Rezoning Transportation Analysis

Petition Number: 2022-193

Date	Description
3-22-23	First Review (TM)

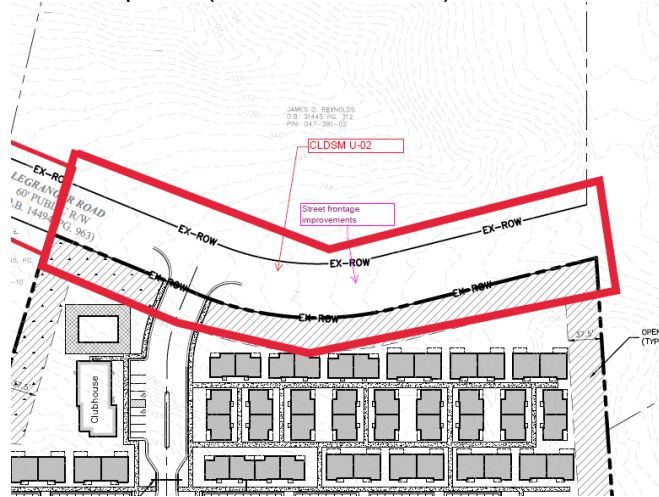
1. Curblines:

- a. **Legranger Road:** Location of curb and gutter to be 13 feet from roadway centerline to accommodate a roadway typical section matching Charlotte Land Development Standards Manual (CLDSM) U-02.

Label and dimension the curb and gutter from the centerline for each road on the site plan.

- 3. Revise site plan and conditional note(s) to commit to dedicate a minimum of 28' right-of-way from the road centerline. The site plan shall label and dimension the right-of-way from the road centerline.
- 4. Revise site plan and conditional note(s) to commit to construct an 8-foot planting strip, and 6-foot sidewalk on Legranger Road per Chapter 19. The site plan shall label and dimension both items from the back of curb and gutter or edge of pavement.

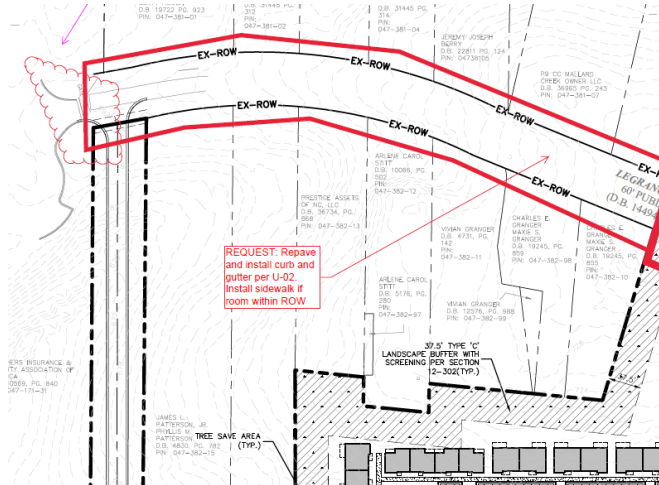
5. Revise site plan and conditional note(s) to commit to reconstructing Legranger to meet CLDSM U-02 standards along sites frontage including sidewalk, curb and gutter. Roadway improvements shall be coordinated with adjacent development (SDRU-2022-00007).

6. **CDOT REQUEST 03-23-23:** CDOT request that Legranger is revised to meet CLDSM U-02 between the sites frontage and the proposed site access to plan west. If this section is not complete the western most site access location shall be required to be restricted to emergency vehicular entrance only. This entrance shall be gated with a knox box.
